A Fire trail, a serious need to assist fire management or just an excuse to knock over more trees?

North Coast Water's Review of Environmental Factors Southern Fire Trail and Access Way.

20th February 2010

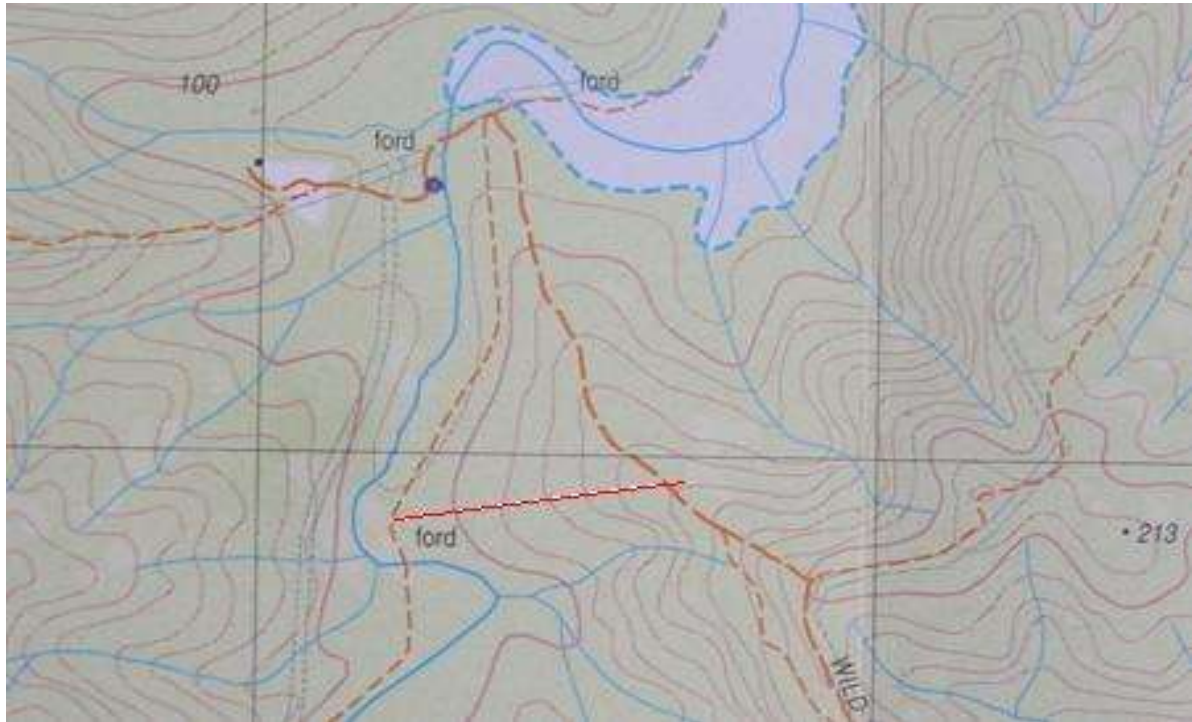
Now that we have assessed the REF we find that, like many former ecological assessments presented to the public in relation to the Regional Water Supply Scheme, not all is exactly as it is presented. The following graphic, Figure 2, on page 12, shows the proposed fire trail (red line), and the author has used a black line to show the supposed position of existing tracks which the proposed trail is to connect.

Note that the aerial photograph has clearly picked up the light shaded line of the existing track from which the proposed trail is attached at its eastern end (right hand end), then note the lack of any similar shading along the black line depicting the supposed existing road at the western end of the trail.

Now compare the previous image with the latest 2003 topographical map.

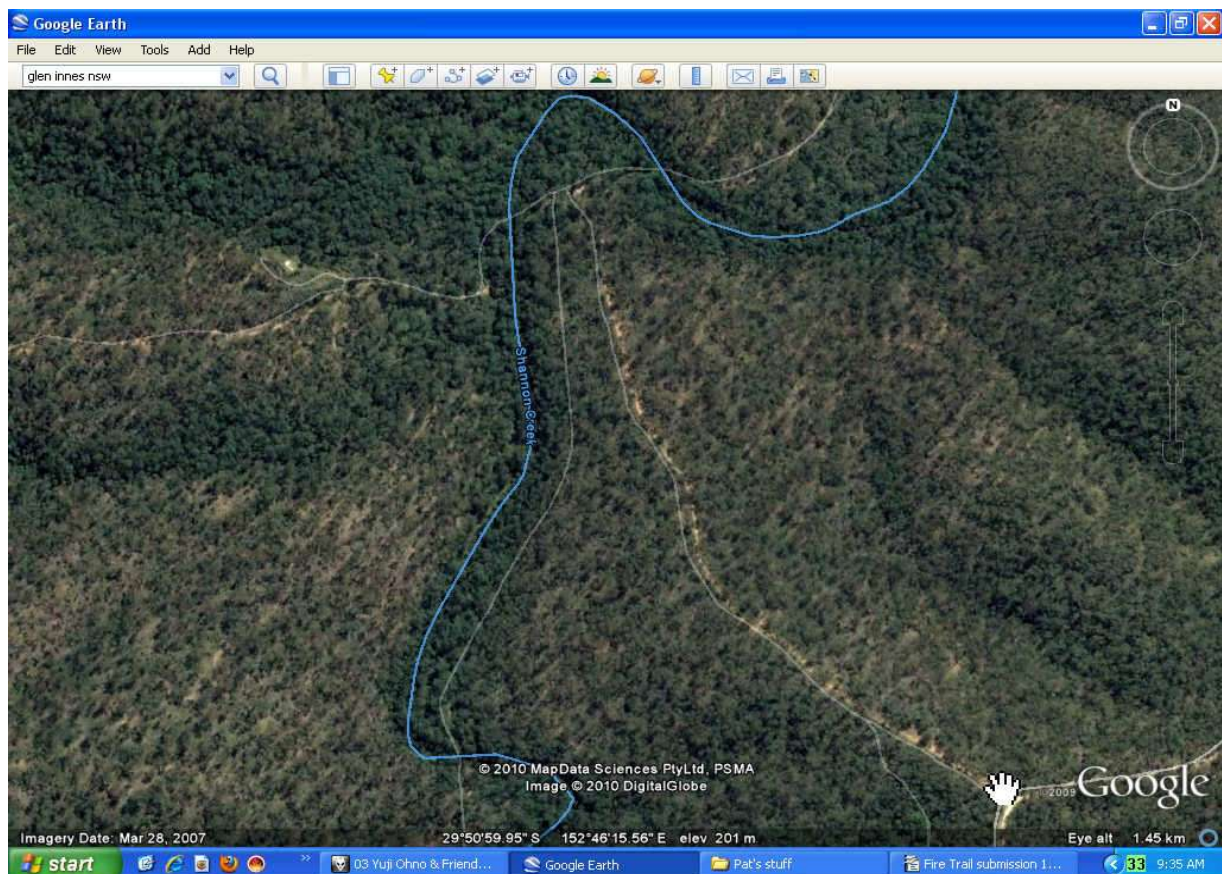
The above map clearly shows the trail at the western end of the proposed track (in red) does not cross the creek, as depicted in the REF image by way of a drawn black line, but follows the eastern side of the creek to the junction next to the dam. This map is supported by the 2007 Google Earth image below.

These images suggest that, not only is there no track crossing Shannon Creek at the western end of the proposed trail, but that the track at the eastern end actually joins a T junction at its northern end (at top) **which is above the dam's high water**, and will adequately provide the required fire access.

If these images are right, considerable impact on riparian habitat will occur to construct a crossing over Shannon Creek, habitat which appears on the Google Earth image to be healthy and intact. Also, before finally joining the T junction at the northern end (top), another creek line will have to be crossed. None of this impact is mentioned in the REF.
